**Proposed Temporary Warehouse (Excluding Dangerous Goods Godown) with Ancillary Facilities
and Associated Filling of Land for a Period of 3 Years in "Agriculture" Zone,
Various Lots in D.D. 107 and adjoining Government Land, Kam Tin, Yuen Long, New Territories**

(S.16 Planning Application No. A/YL-KTN/1118)

1st Further Information

Annex I – Response to the Comments of Chief Engineer/Mainland North, Drainage Services Department (CE/MN, DSD)

Fig.1

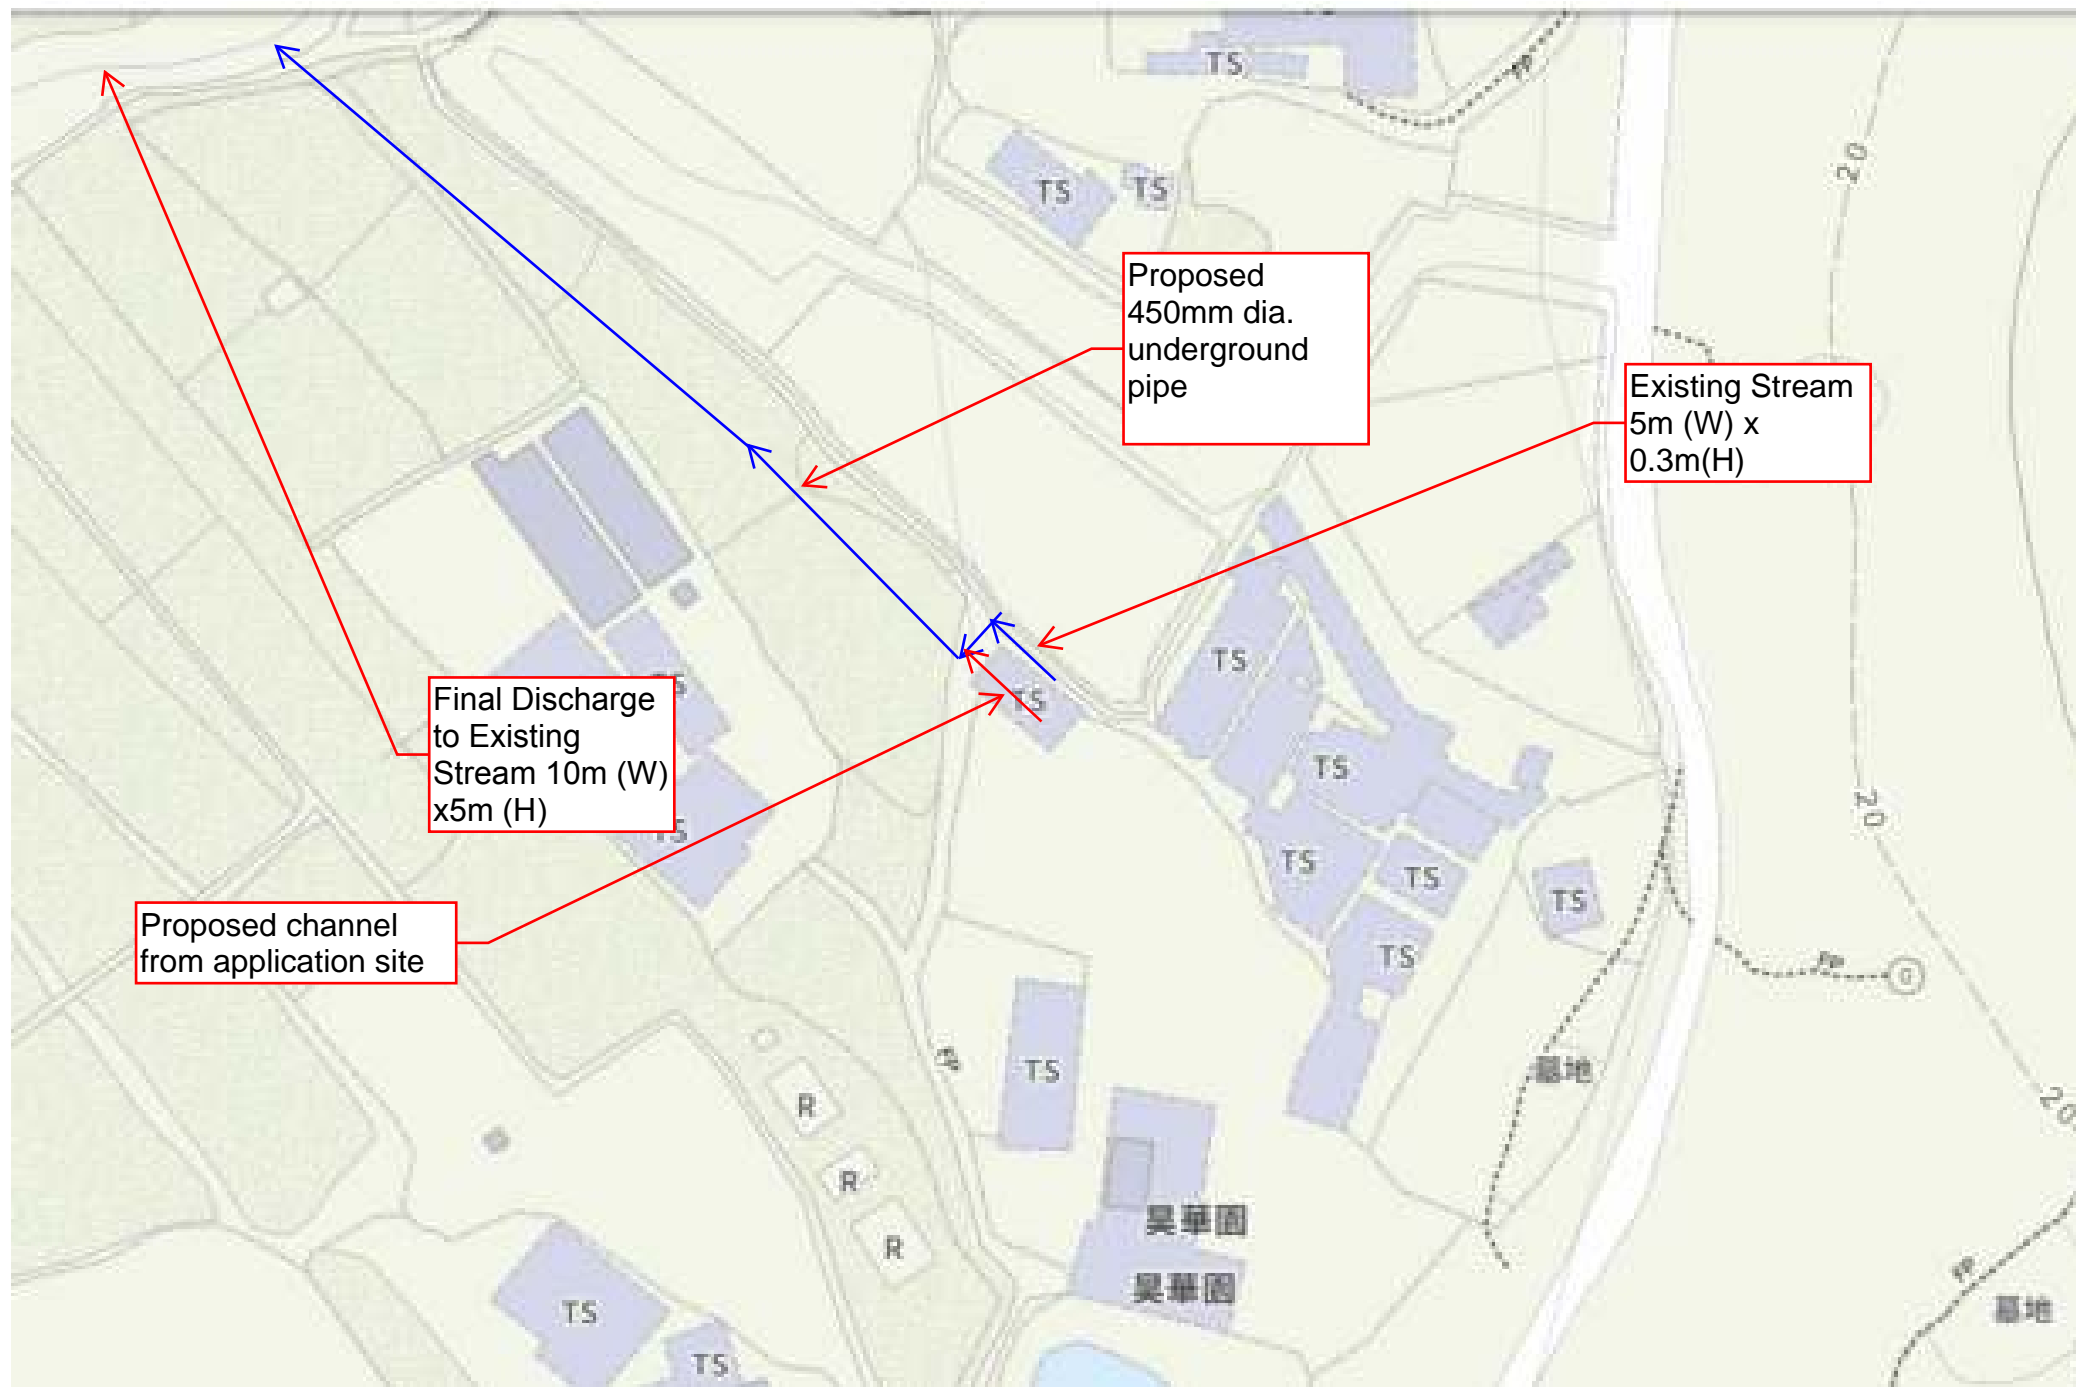
(2)	Fig 1 and the page after Fig 1 – The size of proposed underground pipe is inconsistent;	Noted and revised accordingly (Annex II).
(3)	Connection details - CP9 is not connecting to existing stream as shown in the drainage layout plan. All proposed invert levels including the final discharge level should be given;	Noted and revised accordingly (Annex II).

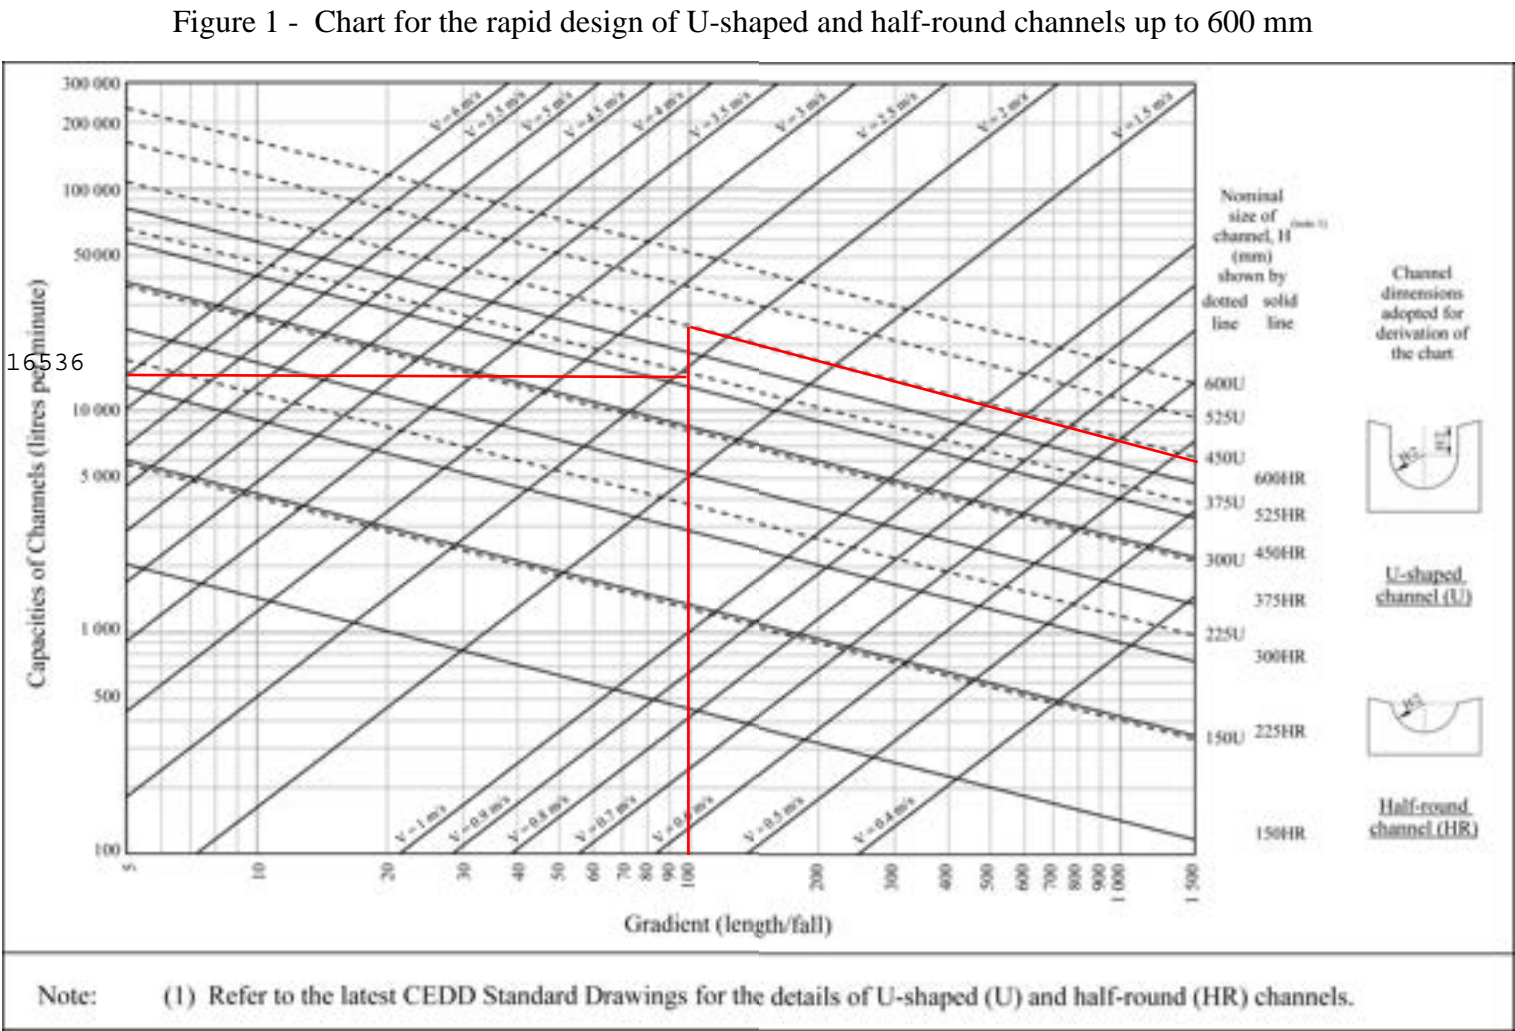
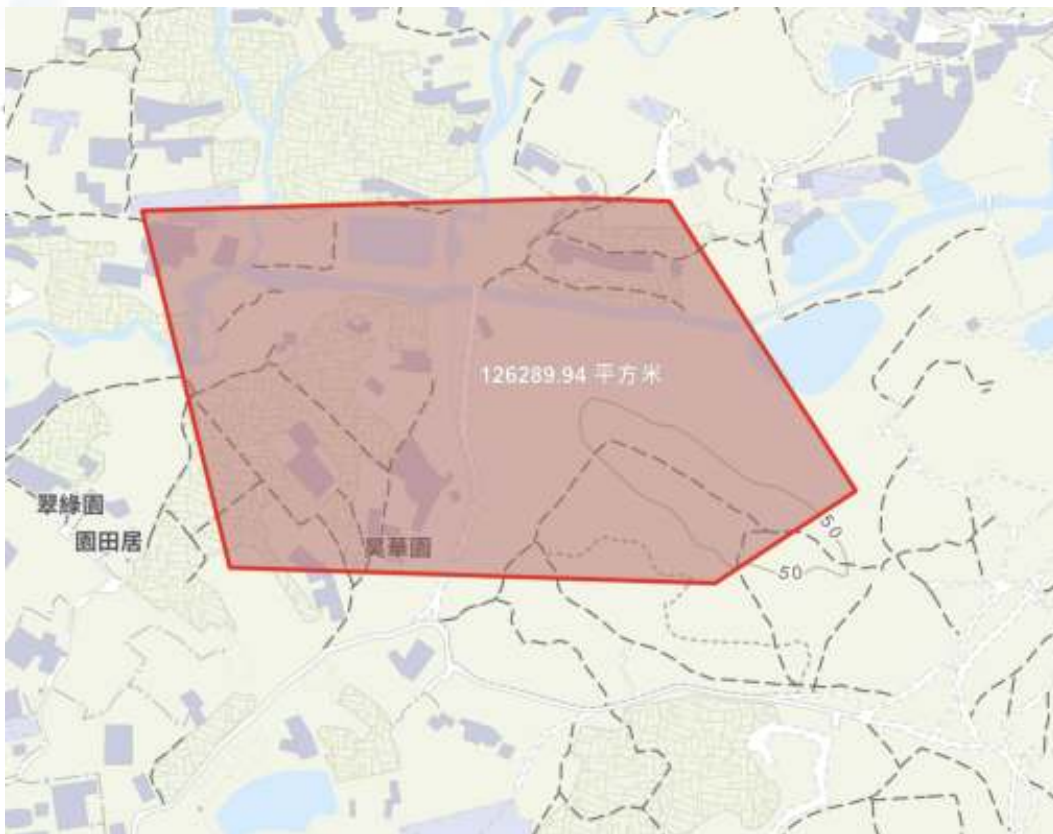
(4)	Calculations – Please justify why runoff coefficient 0.4 is taken;	Noted. The Runoff Coefficient is justified in Figure 2 (Annex II).
(5)	Please review if view 2 and view 3 are correctly shown the right location;	Noted and revised accordingly (Annex II).

Fig.8. Eye Location Plan for Site Photo

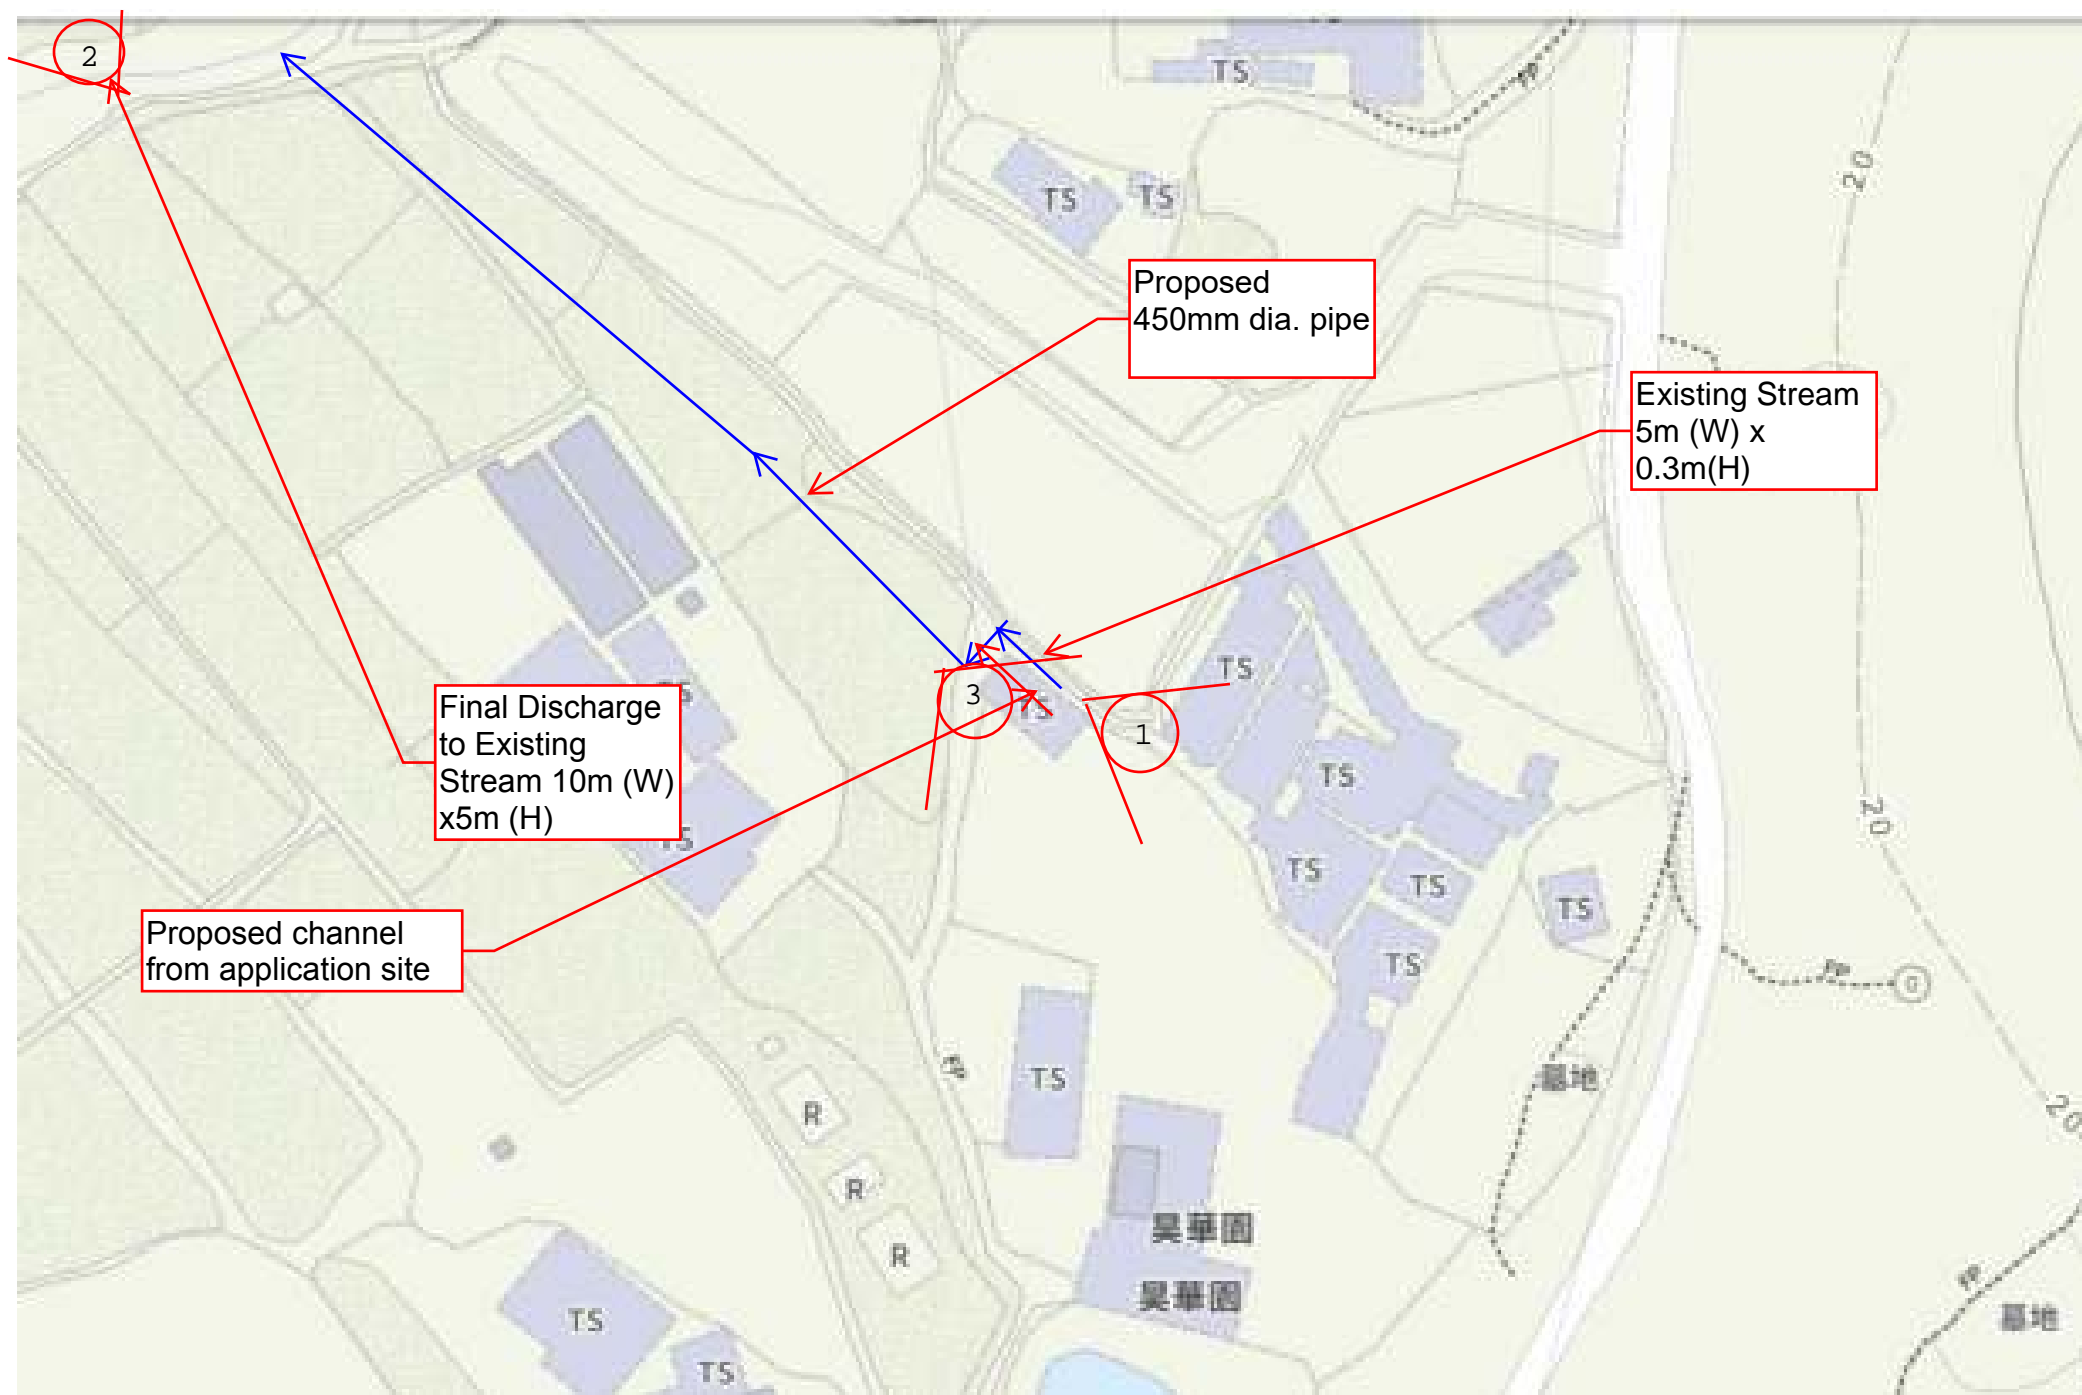
(6)	View 3 – Please advise the road cover depth for the proposed underground pipe. Relevant road design standard and requirement should be complied;	Noted. 450mm soil cover for all underground pipe (Annex II).

AT Least 450mm soil cover for underground pipe
